Re: **Request for Access to Records under the Freedom of Information and Protection of Privacy Act (the "Act")**

1. **Tree Management Plan and Arborist Report for construction activity at 8569 Cartier Street and;**
2. **Arborist Report referenced during permit application process for 1425 West 70<sup>th</sup> Avenue.**

One and two Family Dwelling/Laneway House – Intake Checklist Ver.3 (Dec. 2019)

Address: 8569 CARTIER ST.

Tree Management Plan, Scale 1/16" = 1'

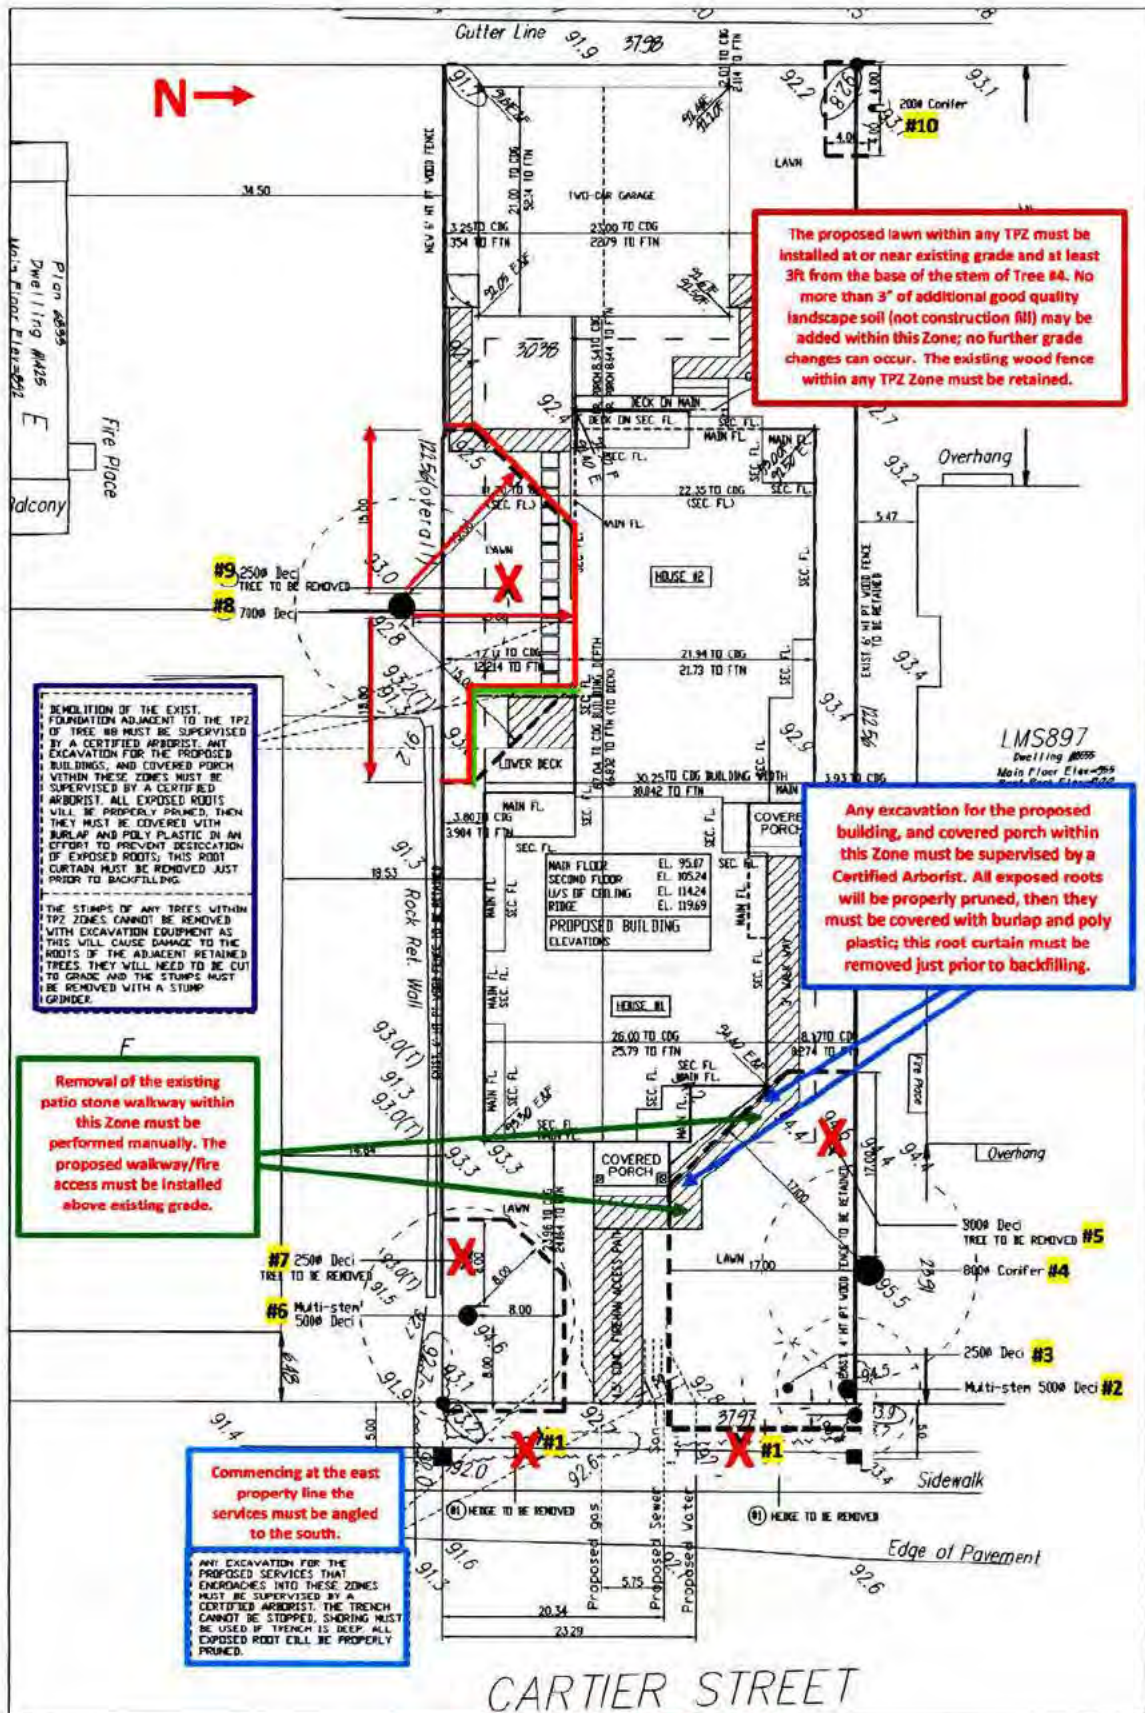
✓		a. Trees keyed with Arborist Report
✓	✗	b. Trees identified for Retention or Removal <i>TREE #3 TO BE RETAINED - UPDATE SITE PLAN NOTE</i> - complete with Replacement Trees as per Sec. 6.3 of Protection of Trees Bylaw No.9958
✓		c. Tree Protection Barriers - barriers are scaled and dimensioned from edge of trunk or equivalent - barriers do not conflict with existing or proposed development, confirmed in the Arborist Report
✓		d. Utilities - No connections, lines or sumps proposed in Critical Root Zone (CRZ) without signoff from Park Board or Consulting Arborist. - Sewer Water Permit, approved by City of Vancouver Engineering
✓		e. Arborist's specifications on plans - Arborist involvement areas and special construction practices are clearly indicated.
✓		f. Proposed grade changes impacting tree retention indicated on plans and concurrent with Sec. 8 of Protection of Trees Bylaw No.9958
✓	✗	g. Detail drawings provided for proposed disturbances within Critical Root Zone (CRZ) - Note: unnecessary work within CRZ will be rejected

Comments: 2h). FRONT WALKWAY WITHIN CRZ OF TREE #4 TO BE REMOVED

AND REPLACED WITH SHARED PATHWAY. (FIRE ACCESS) ✓

• NOTES FOR EX FENCE TO BE RETAINED - ADD TO PLANS

• UPDATE NOTE FOR S WALKWAY TO BE BUILT ON TOP OF GARAGE WITHIN TPZ

LOA should include install pathway within CRZ of tree #4,5!

↳ will address at further review stage
